UNITED STATES PATENT AND TRADEMARK OFFICE

APPLICATION NO.	FILING DATE	FIRST NAMED INVENTOR	ATTORNEY DOCKET NO.	CONFIRMATION NO.
10/048,165	01/29/2002	Martin Caldwell	741890-0023	4375
22204	7590	06/10/2004	EXAMINER	
NIXON PEABODY, LLP 401 9TH STREET, NW SUITE 900 WASHINGTON, DC 20004-2128			PANTUCK, BRADFORD C	
			ART UNIT	PAPER NUMBER
			3731

Office Action Summary

DETAILED ACTION

Fig. 2B

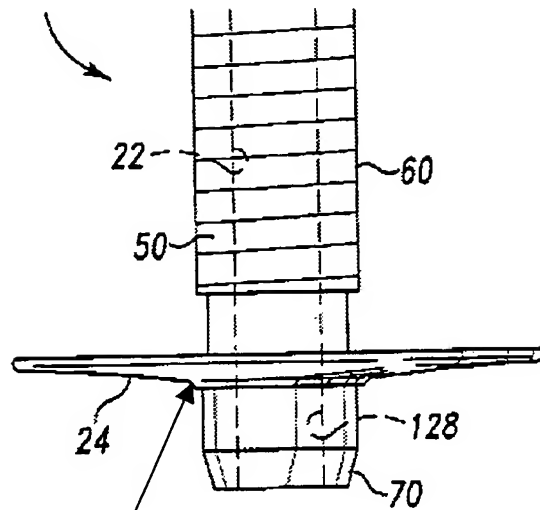
16. Regarding Claim 18, the entry port (central hole in seal 24) has a conical section, as is evident in the below drawing:

Conical
flange
